SERVICE LETTER

No. 793

Piper Aircraft Corporation

Flap Warning Placard

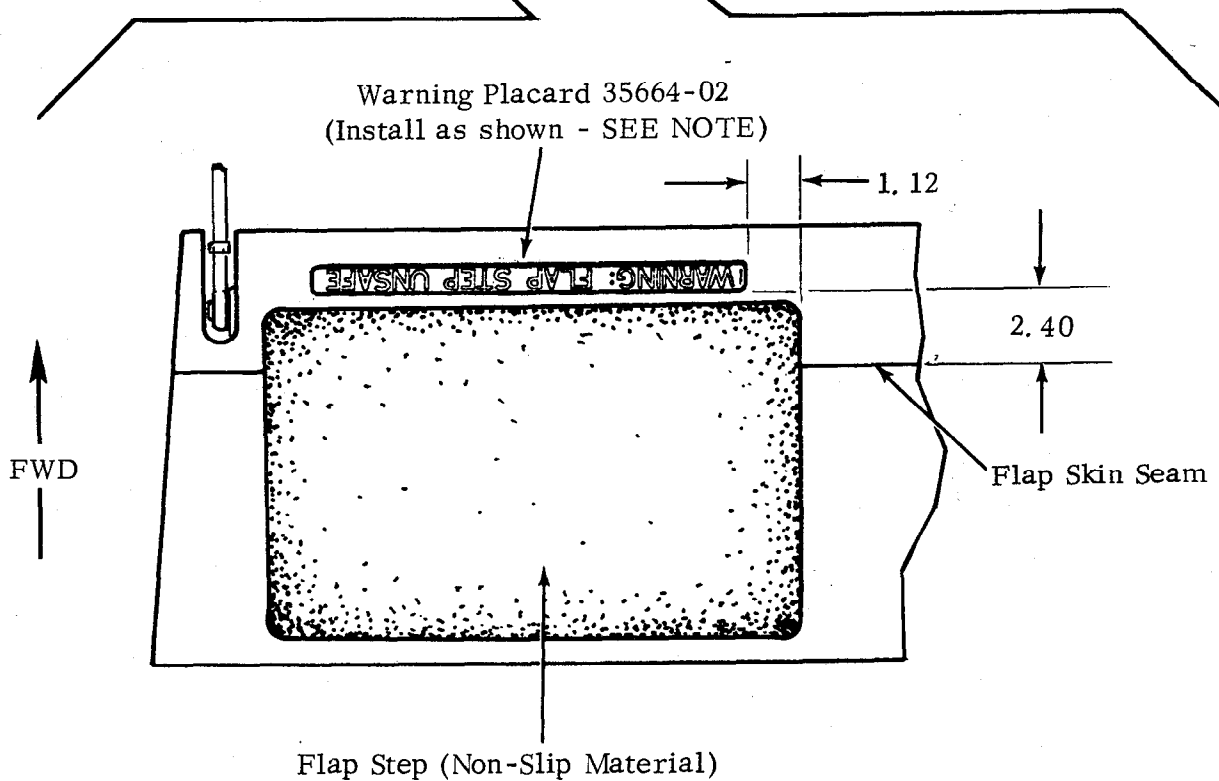
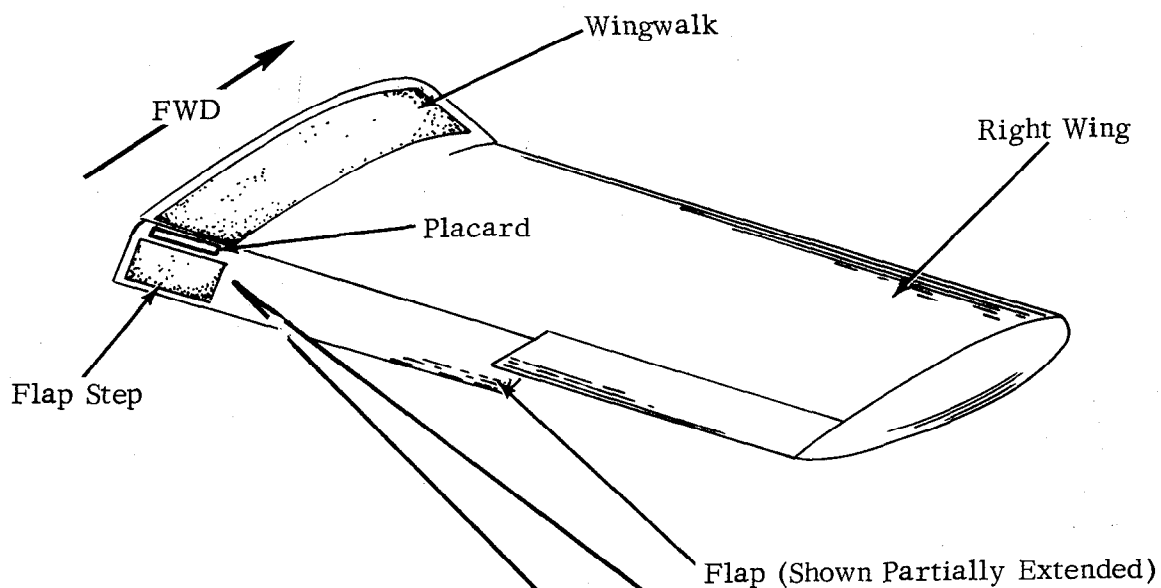
Instructions: Apply placard per attached instructions data.

Material Required: One (1) each per aircraft, Piper Part Number 35664-02 Warning Placard @ suggested unit list price \$.65C.

NOTE: If required, it is permissible to trim forward edge of flap step material in order to install the placard at the dimensions shown. Seal trimmed edge with 3M Edge Sealing Compound #62-5569-2660-8 (5 oz. Tube - Piper P/N 914 055).
